**Re: Planning Review #2
Application #14-21
Site Plan w/ Variances
Block 1901, Lot 40
40 Russo Place
Michael Cline c/o First Student, Inc.
LI Light Industrial District**

This is the second review letter issued in association with the above-mentioned project. The applicant proposes to convert the existing site, which is currently used by a non-conforming environmental waste recovery company, into a school bus parking lot with associated administrative office space. Following the initial hearing, the applicant has provided revised plans and additional materials; we are in receipt of and have reviewed the following:

Figure 2: Location of Flood Hazard Areas (in blue)

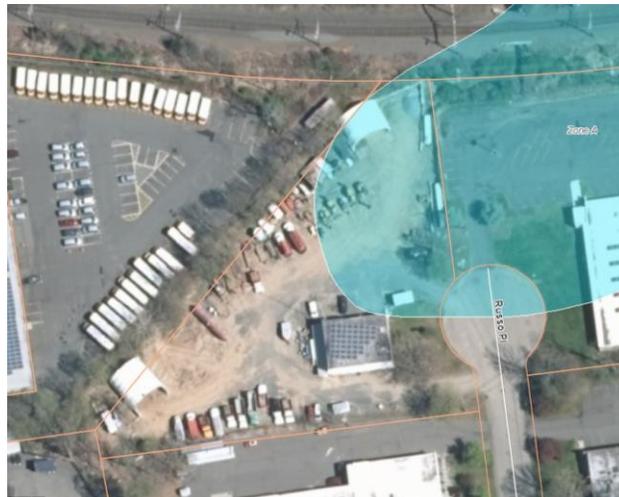
- Improvements within flood hazard areas: according to the FEMA National Flood Hazard Layer Effective Panel for New Jersey, a portion of the site is located in Flood Hazard Zone A – i.e. 100-year flood plain (see Figure 2). As such, improvements and activities in those areas would require approval from the NJ Department of Environmental Protection. It should be noted that no Letter of Interpretation has been submitted with this application.

The applicant in the Response Letter notes that they have scheduled a meeting with NJDEP to review the project requirements within the flood hazard area.
